Job 72514388REP1 72510073REP2	Truss V6	Truss Type Truss	Qty 1	Ply 1	LGI HOMESICARY RF Job Reference (optional)
-------------------------------------	-------------	---------------------	----------	----------	-----------------------------------------------

Job	Truss	Truss Type	Qty	Ply	LGI HOMESICARY RF
72510073REP2	V7	Truss	1	1	Job Reference (optional)

Job	Truss	Truss Type	Qty	Ply	LGI HOMESICARY RF
72510073REP2	V8	Truss	1	1	Job Reference (optional)

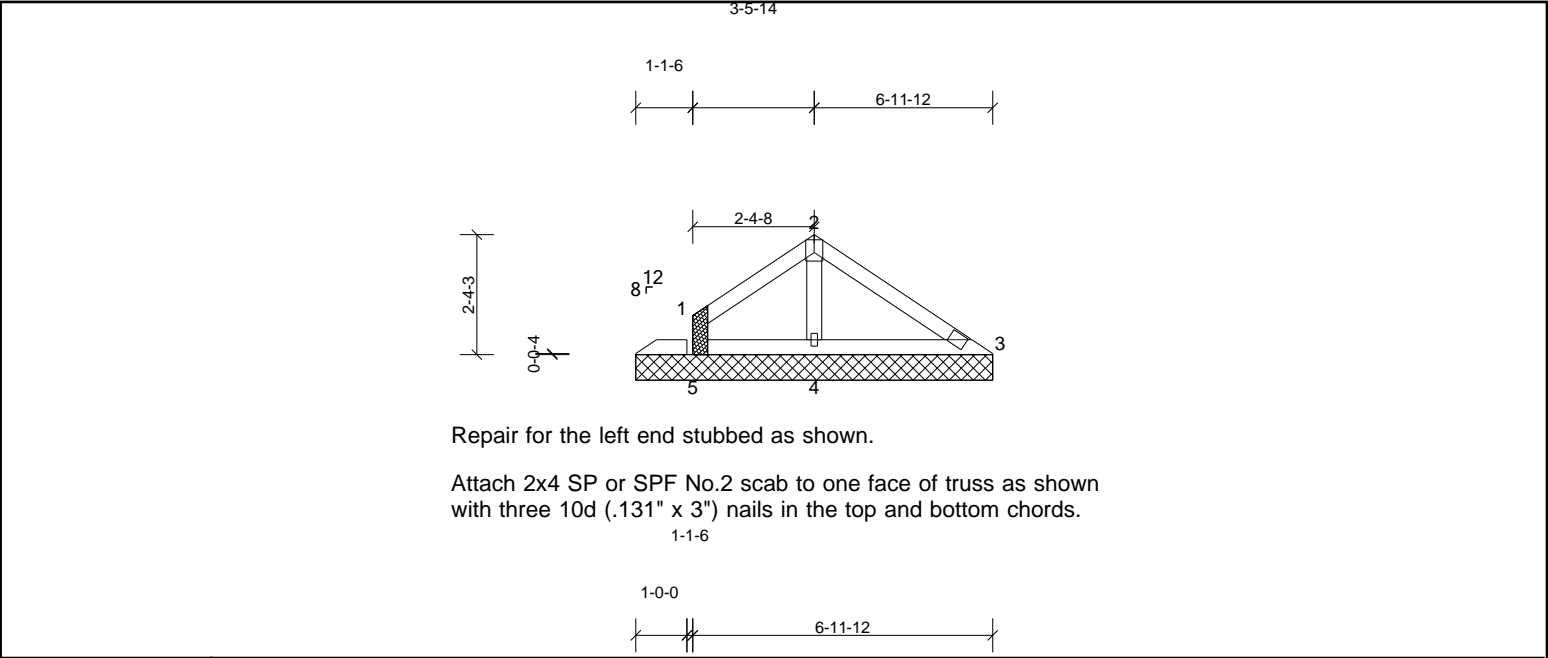
Repair for the left end stubbed as shown.

Attach 2x4 SP or SPF No.2 scab to one face of truss as shown with three 10d (.131" x 3") nails in the top and bottom chords.
